# BCA Assessment Report

200 Aldington Road, Kemps Creek  
Warehouse W4A & W4B, Lot E

SSDA – 85510213  
MOD 6

**Revision 2**  
3 October 2025  
Reference: S250200

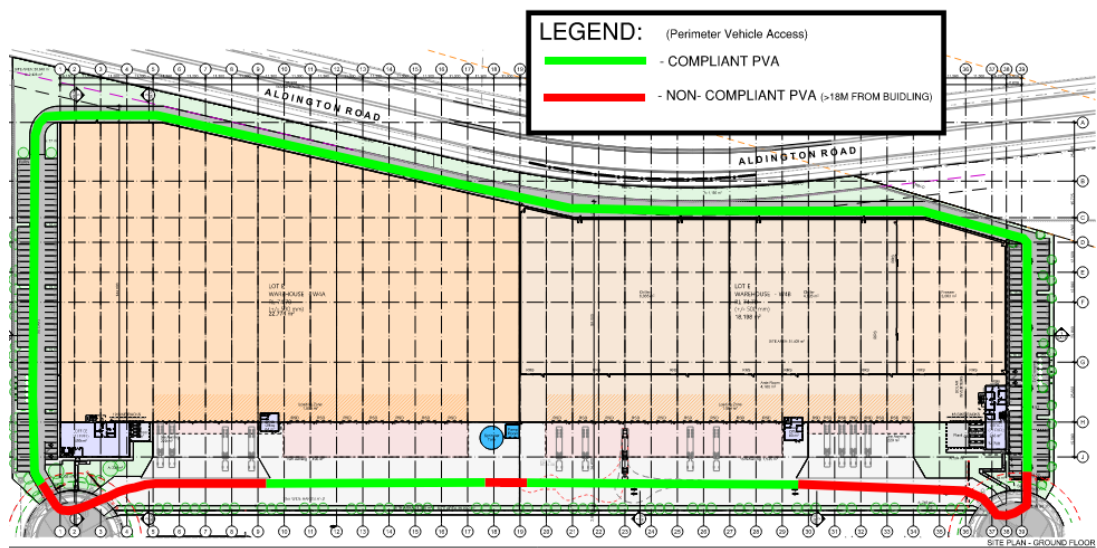
**Comment:** It is understood that a **Fire Engineered Performance Solution** is proposed to address the perimeter vehicular access, as it is, in parts, greater than 18m from the external walls, as shown below.

Figure 2: Additional suggested exit door location (W4B office)

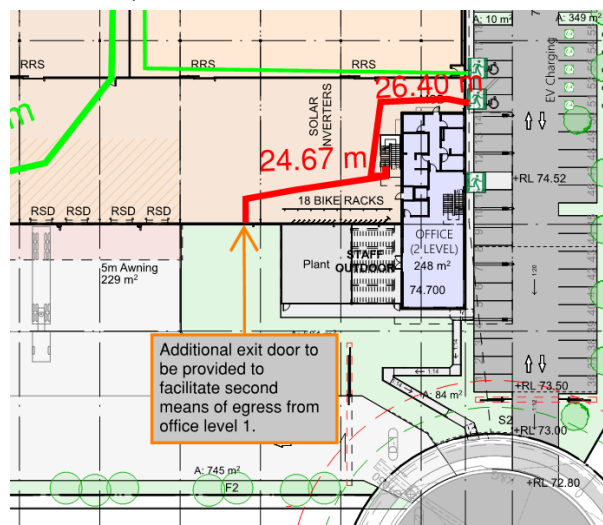
**Comment:** The provided plans demonstrate compliance with respect to W4A, however an additional exit door will be required to be provided to facilitate compliant egress distances from the First Floor of Office W4B as per the below:
